## XC2300C Derivatives

Errata Sheet

V1.6 2013-03

**Figure 1 Critical application reset sequence**

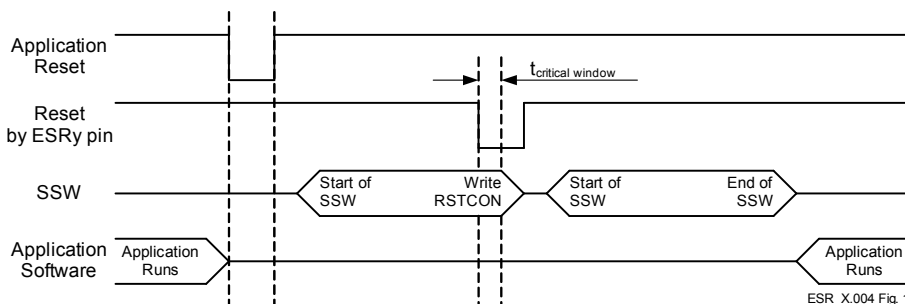
SCU\_RSTCONx registers are reset only by Power-On, but they may be wrongly affected after a second application reset requested by an ESRy pin. This may lead to the SCU\_RSTCONx register values being set to zero, which could unexpectedly disable reset sources within the user application. The conditions which lead to this behavior are:

1. First, an application reset by SW (software), CPU (Central Processing Unit), MP (Memory), WDT (Watchdog Timer) or ESRy (External Service Request y) occurs.
2. Following this, an application reset on an ESRy pin occurs.
3. If the above mentioned ESRy reset occurs during a critical time window of the SSW (startup software), then it's possible that the application will operate with the wrong SCU\_RSTCONx register value. The critical time window occurs when the SSW is writing the SCU\_RSTCONx registers, and

at the same time, the ESRy reset request is processed by the reset circuitry. The width of this critical window  $t_{\text{critical window}}$  is less than 13 cycles.

- Initialize `SCU_RSTCONx` registers by user software after any reset, or
- assure that a second application reset request with an ESR pin does not occur during the critical time window.

**Figure 2 Example for a Slow Input Signal**

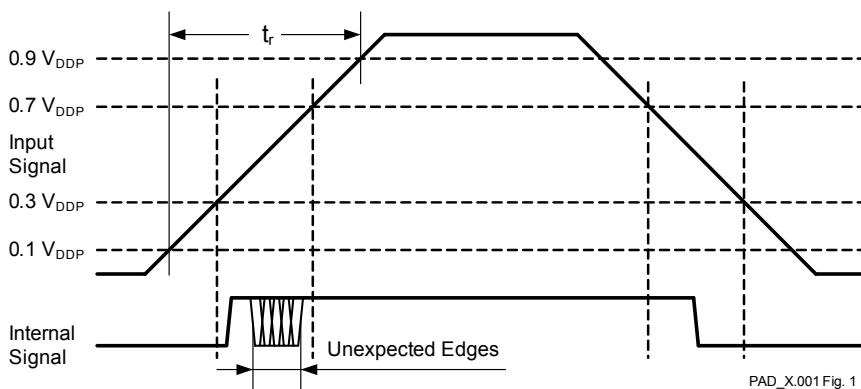
The next picture **Figure 2** is an example for a slow input signal, with spikes shown on the slow rising input signal.

The first rising edge in [Figure 2](#) of the internal signal is always valid. The edges which are marked with “Unexpected Edges” must be ignored.

**Figure 4 Rising Edge Detection Approach**

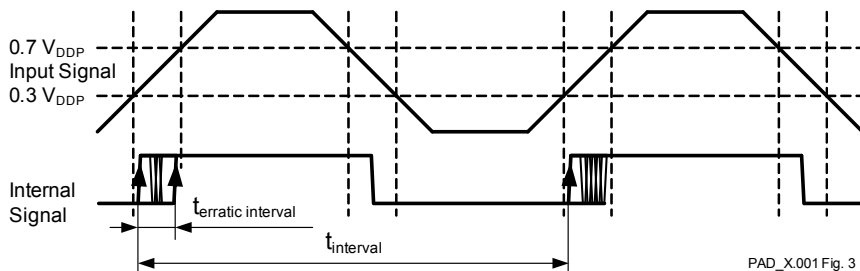
In case of rising edge detection multiple interrupts would be generated when the spike occurs. The time interval since the last interrupt can be measured – if it is very small compared to the expected value, this would indicate a spike and the interrupt should be ignored.

The preferred solution for interrupt handling is to use the rising edge detection.

**Figure 6 Alert Interrupt Behavior in case of Bus-Off**

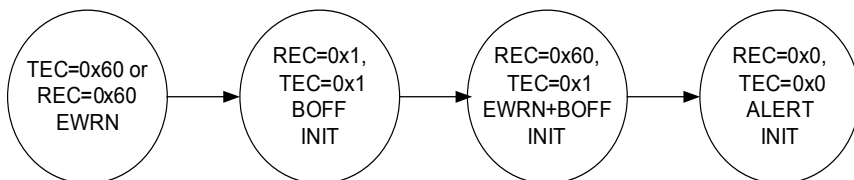
When the threshold for error warning (EWRN) is reached (default value of Error Warning Level EWRN = 0x60), then the EWRN interrupt is issued. The bus-off (BOFF) status is reached if  $TEC > 255$  according to CAN specification, changing the MultiCAN module with REC and TEC to the same value 0x1, setting the INIT bit to 1<sub>B</sub>, and issuing the BOFF interrupt. The bus-off recovery phase starts automatically. Every time an idle time is seen, REC is incremented. If REC = 0x60, a combined status EWRN+BOFF is reached. The corresponding interrupt can also be seen as a pre-warning interrupt, that the bus-off recovery phase will be finished soon. When the bus-off recovery phase has finished (128 times idle time have been seen on the bus), EWRN and BOFF are cleared, the ALERT interrupt bit is set and the INIT bit is still set.

**Figure 7 Loss of Arbitration**

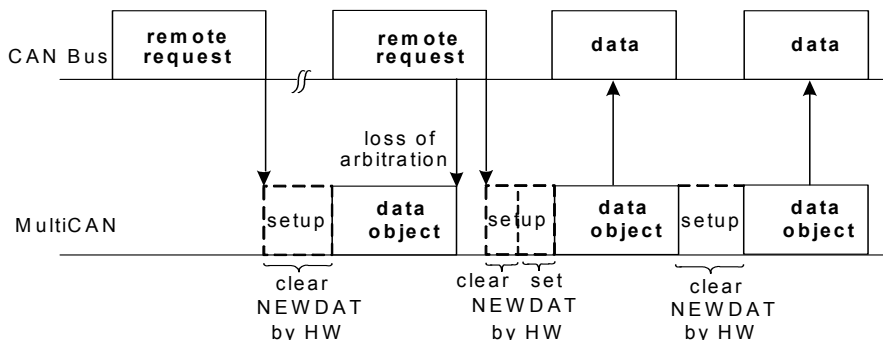
When the appropriate message object (data frame) triggered by the first remote frame wins the arbitration, it will be sent out and `NEWDAT` is not reset. This leads to an additional data frame, that will be sent by this message object (clearing `NEWDAT`).

There will, however, not be more data frames than there are corresponding remote requests.
